APPLICATION NO.	FILING DATE	FIRST NAMED INVENTOR	ATTORNEY DOCKET NO.	CONFIRMATION NO.
10/724,307	11/28/2003	Chi Lam Wong		1426
30265	7590	10/19/2005	EXAMINER	
RAYMOND Y. CHAN 108 N. YNEZ AVE., SUITE 128 MONTEREY PARK, CA 91754			PRICE, CARL D	
			ART UNIT	PAPER NUMBER
			3749	
DATE MAILED: 10/19/2005

Office Action Summary	Application No. 10/724,307	Applicant(s) WONG, CHI LAM	
	Examiner CARL D. PRICE	Art Unit 3749

DETAILED ACTION

FIG. 3

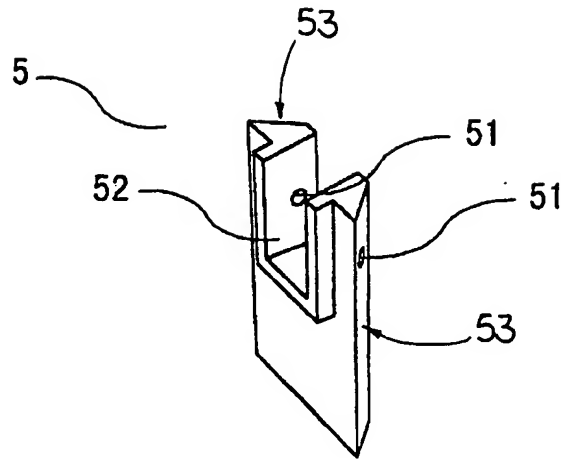
The drawings are objected to because the drawing Figure 3 presented under the Heading “DRAWING AMENDMENTS” in “Attachment 1” of the response filed on 03/21/2005 is not marked “**Replacement Sheet**” or “**New Sheet**” pursuant to 37 CFR 1.121(d). Corrected drawing sheets in compliance with 37 CFR 1.121(d) are required in reply to the Office action to avoid abandonment of the application.

NOT APPROVED
of heading
10/16/05
